NAME OF CUSTOMER: NABINAGAR POWER GENERATING CO. PVT. LIMITED (NPGC)
NAME OF PROJECT : 400/132 KV SWITCHYARD PACKAGE AT NABINAGAR SUPER THERMAL POWER PROJECT (3 X 660 MW)

400KV NABINAGAR TPP (BRBCL) EXTN - SINGLE LINE DIAGRAM

NTPC DRAWING NO. 0370-572-PVE-F-442				
CUSTOMER NABINAGAR POWER GENERATING CO. PVT. LTD. (NPGC)				
PROJECT : NABINAGR STPP (3X660 MW) 400/132kV SWITCHYARD PACKAGE				
	BHARAT HEAVY ELECTRICALS LTD. TRANSMISSION PROJECTS DIVISION NEW DELHI		DEPT CODE	NAME
			DRN	RK
			CHD	SK
		APPD	DKM/RS	
TITLE Equipment Earthing Philosophy & Details				
		DEPT.	SCALE	DRAWING NO.
		SIGN		TB-4-350-316-017
		DATE		SHEET 01 OF 22 REV. 00

EQUIPMENT EARTHING DETAILS NOTES

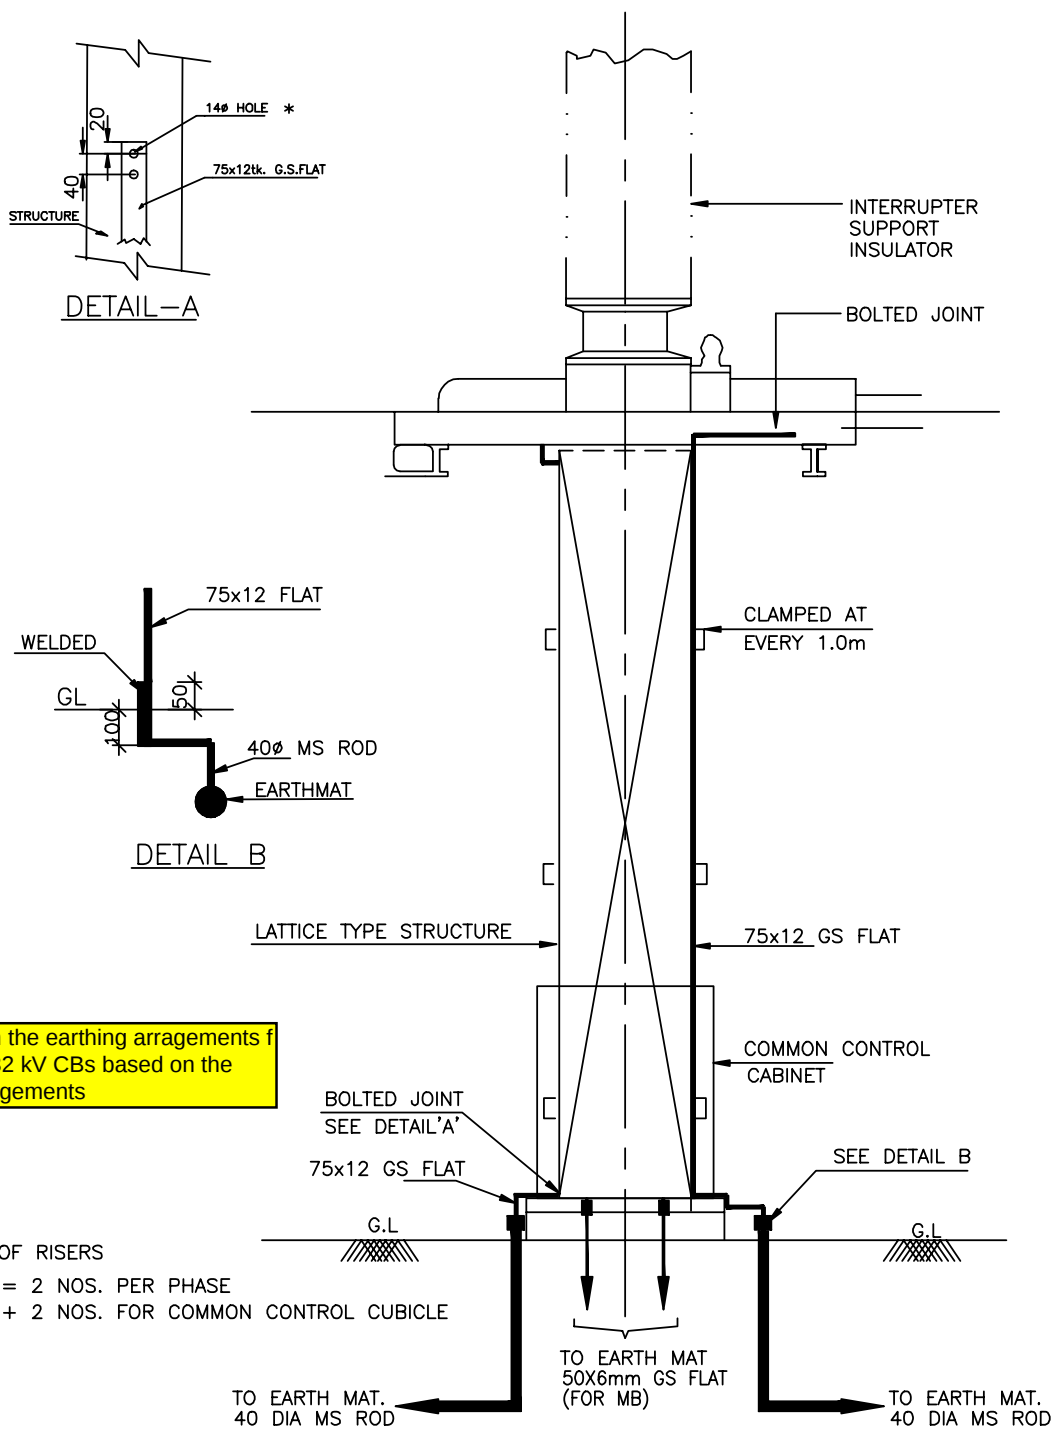
Rod shall be spec requirements/ appro

Pl refer Annexure-I of Chapter-E13 of tech spec for earthing requirements.

400kV & 132kV SF6 CIRCUIT BREAKER

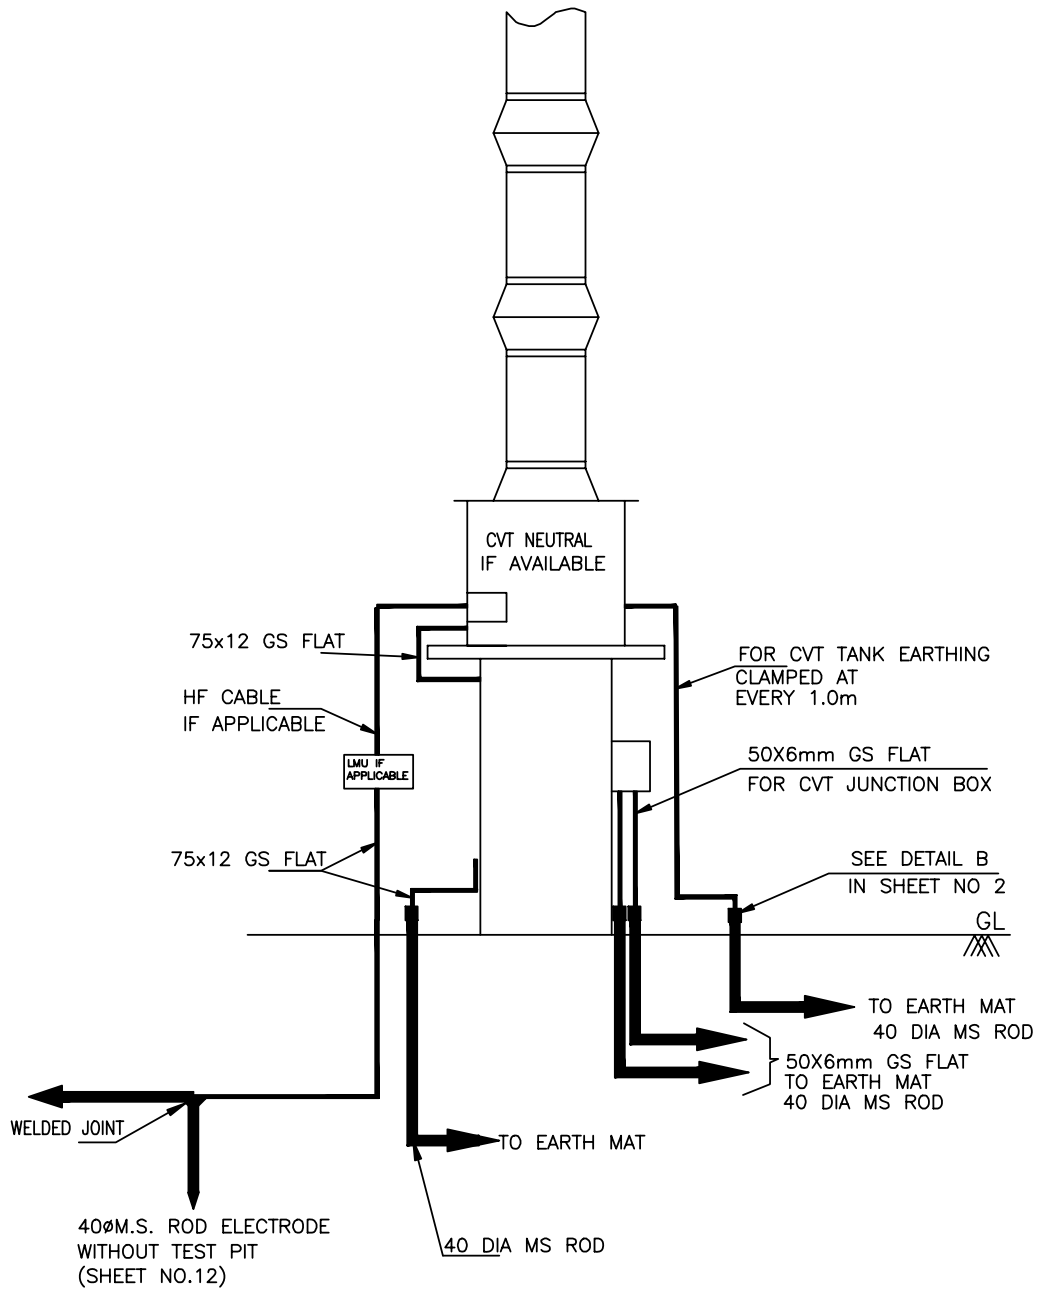
Please furnish the earthing arrangements for 400kV & 132 kV CBs based on the general arrangements

LIGHTNING ARRESTER (390kV, 120kV & 30 kV)

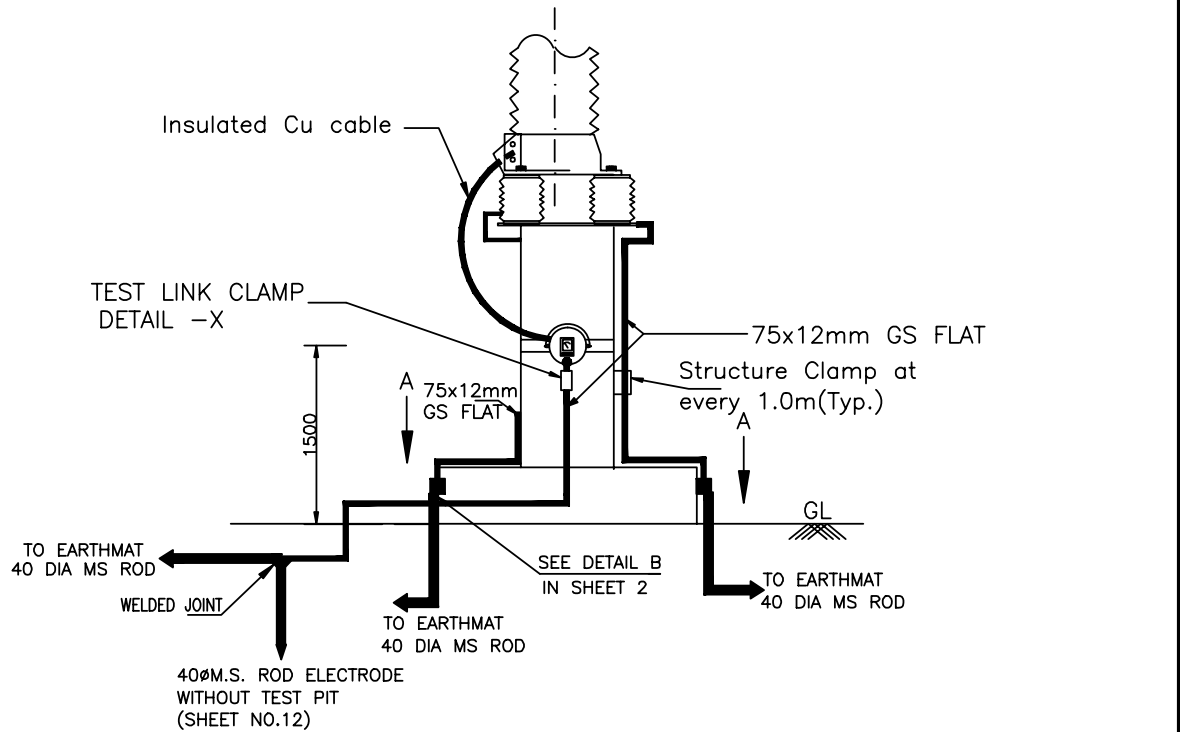
Please furnish the dimensions and details of not & Bolts

400KV HORIZONTAL CENTER BREAK ISOLATOR (TYPICAL) WITH ONE EARTHSWITCH

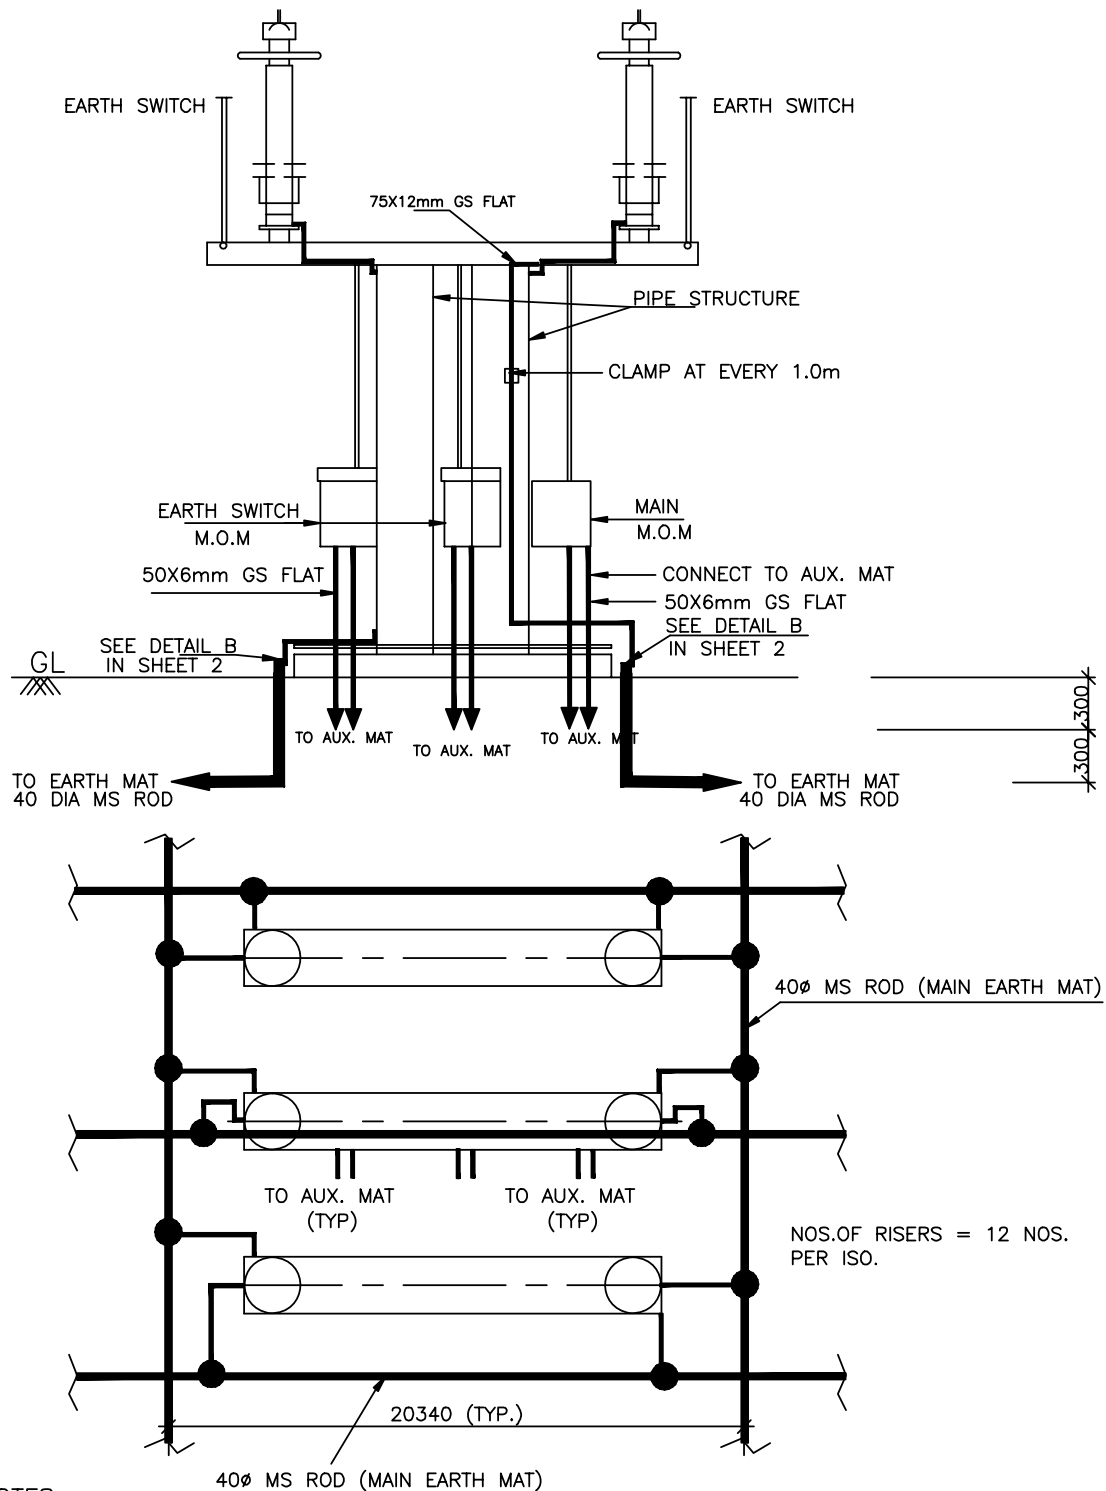
M/s BHEL to ensure the Isolator arrangement drawing

132kV HORIZONTAL CENTER BREAK ISOLATOR WITH TWO EARTHSWITCHES

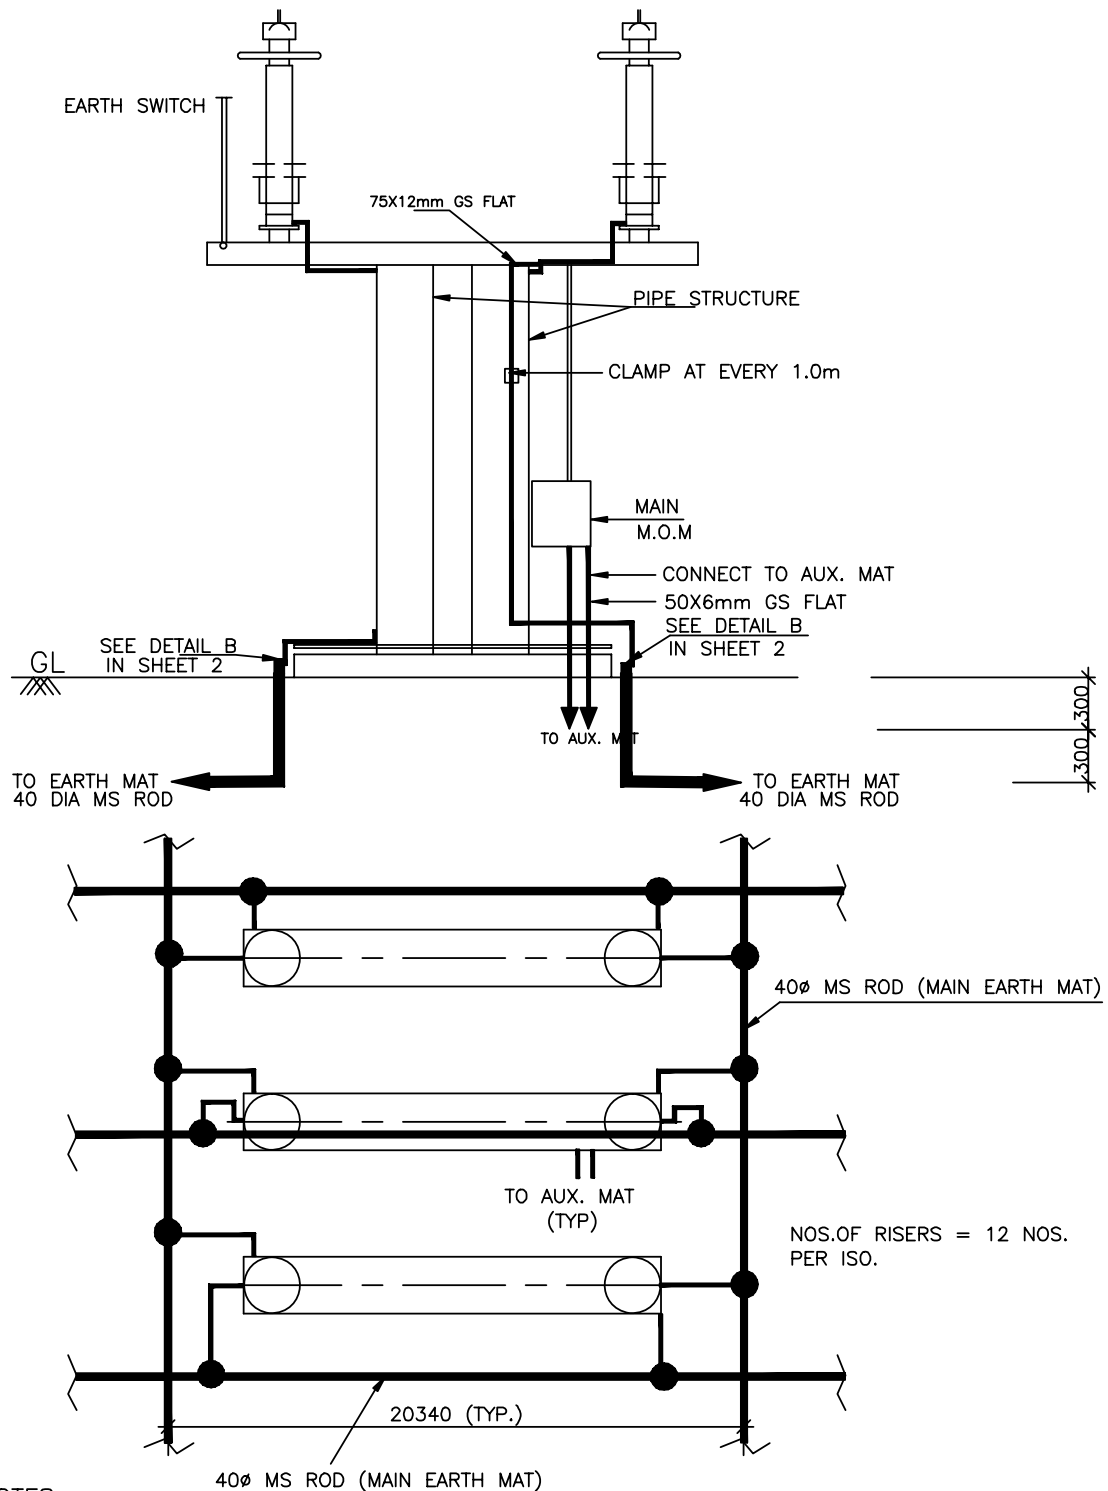
M/s BHEL to ensure the Isolator arrangement drawing

132kV HORIZONTAL CENTER BREAK ISOLATOR WITHOUT EARTHSWITCH

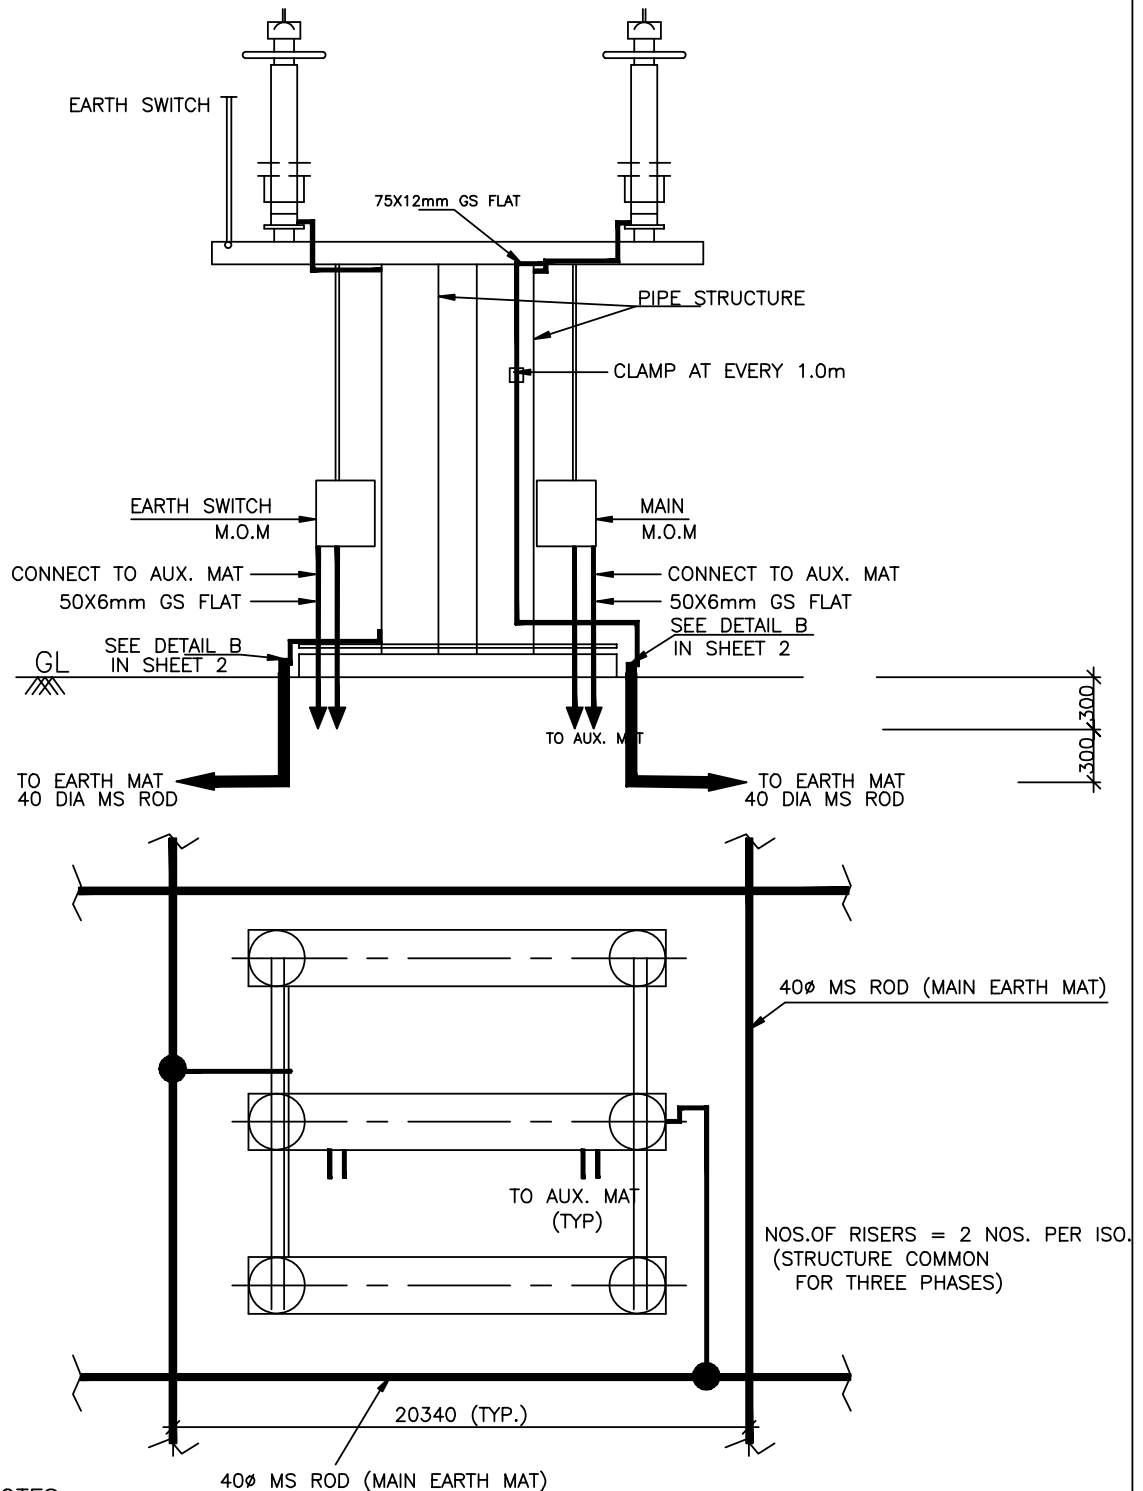
M/s BHEL to ensure the Isolator arrangement drawing

33kV HORIZONTAL CENTER BREAK ISOLATOR WITH EARTH SWITCH

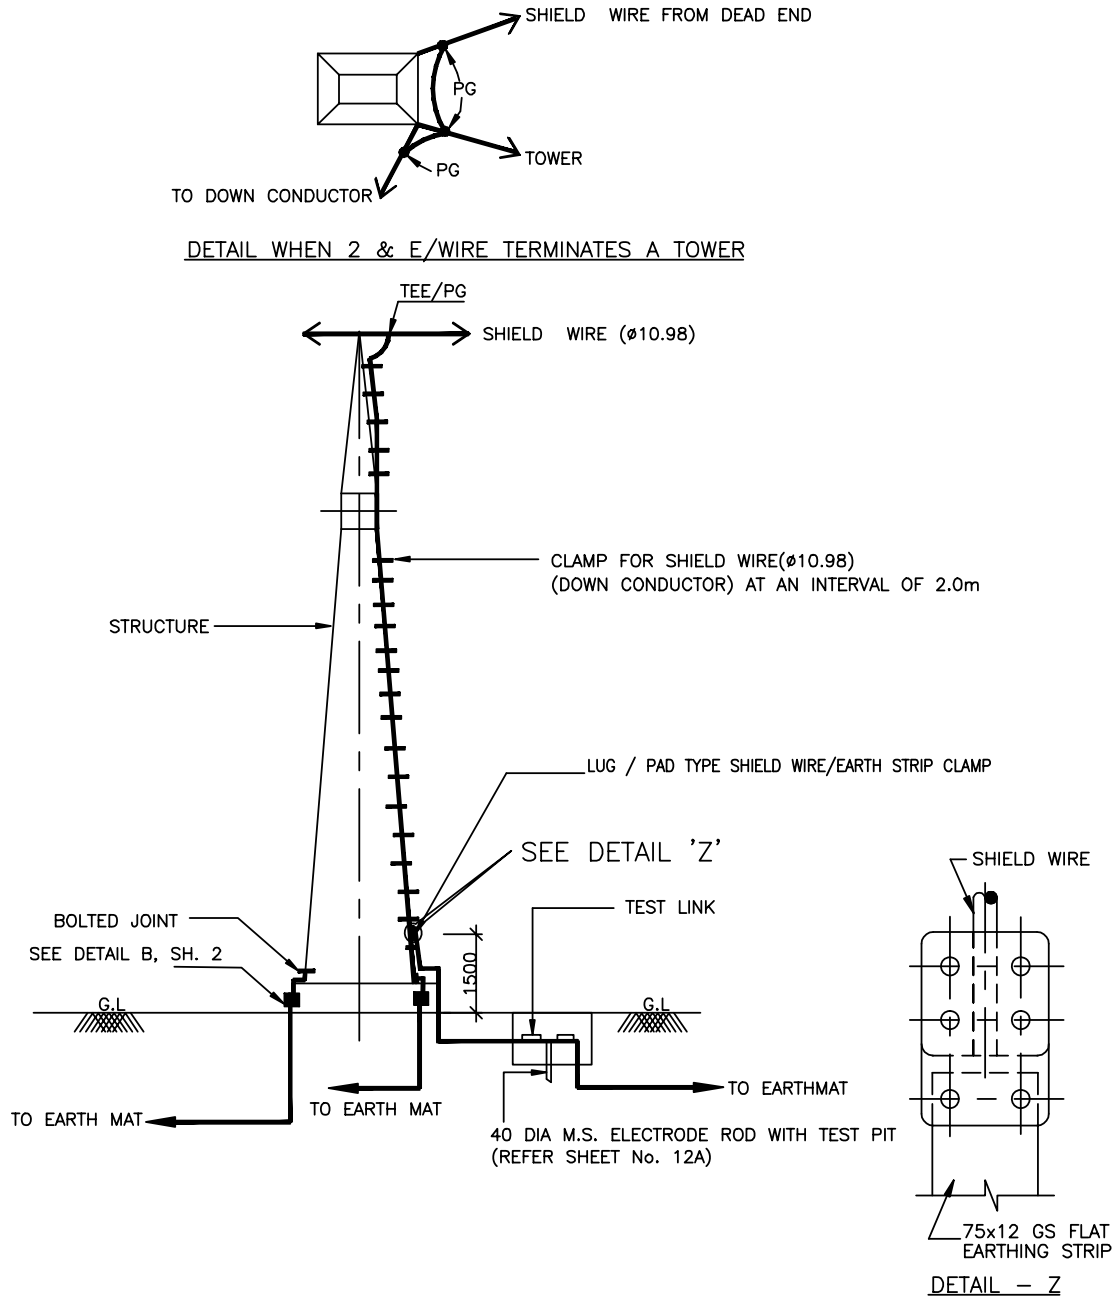
M/s BHEL to ensure the Isolator arrangement drawing

EQUIPMENT EARTHING DETAILS PIPE EARTH ELECTRODE WITH TREATED PIT

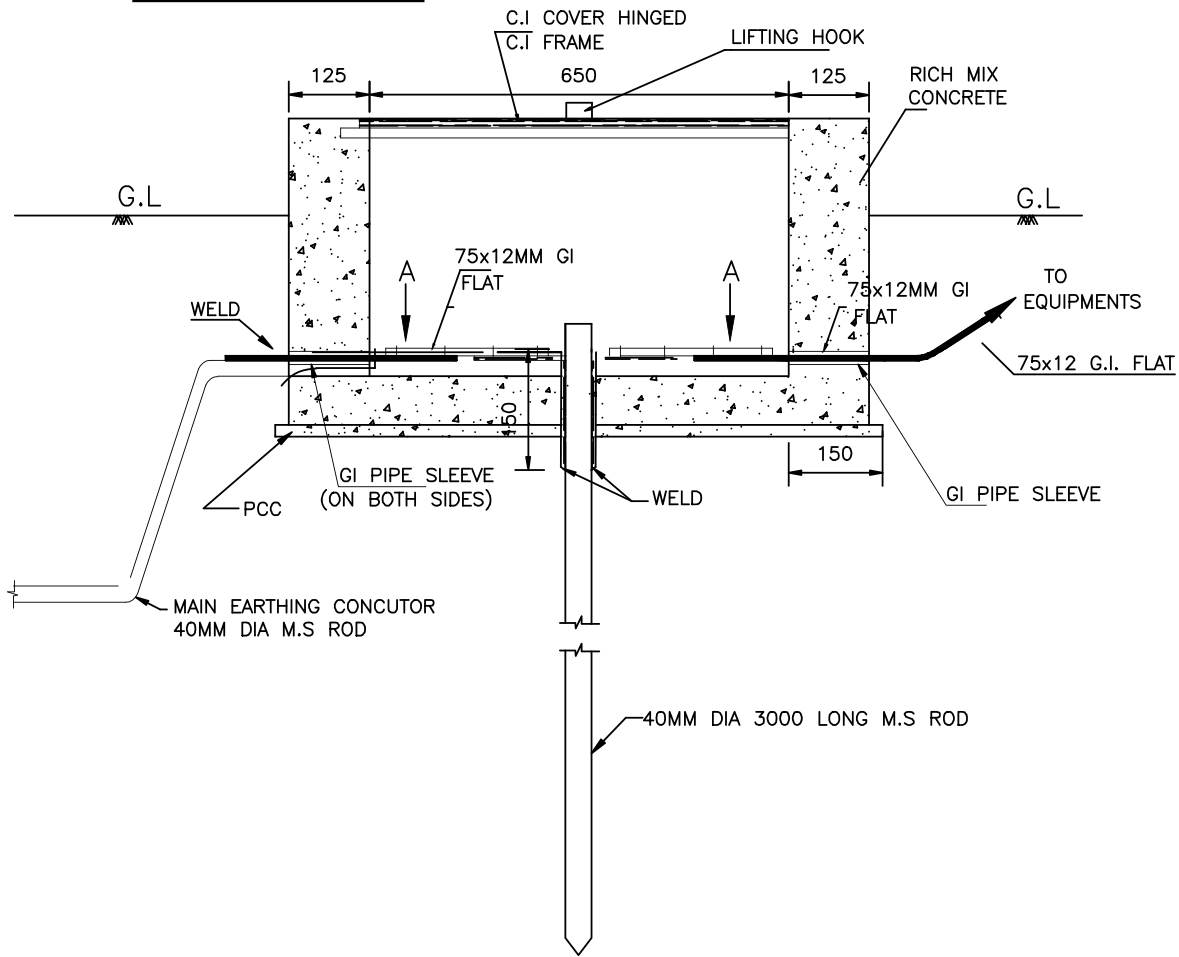
Please furnish the cover detail with its hinged arrangement
